Re: *Addendum No. 1*
Geneva Streetscape Improvements
City of Geneva

Date: March 30, 2026

**Proposal to City of Geneva
For Appalachian Community Grant Improvements
Geneva Streetscape Improvements - Phase 2 - Base Bid
Project No. 0000031538**

WATER MAIN LOWERING DETAIL

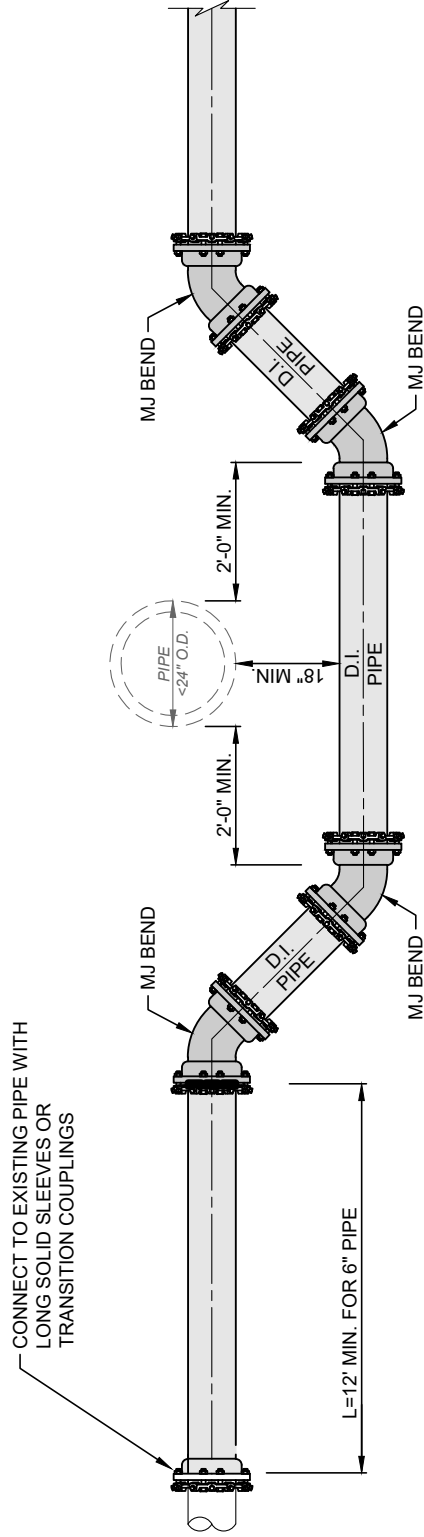
Add attached Water Main Lowering Detail

1. ENTIRE OFFSET INCLUDING BENDS SHALL BE BUILT WITH DUCTILE IRON RESTRAINED MECHANICAL JOINTS, CLASS 52 . IF AN INTERMEDIATE JOINT IS REQUIRED BETWEEN BENDS, THE ENTIRE UNDERPASS SHALL BE BUILT WITH BOLTLESS RESTRAINED PIPE AND FITTINGS.
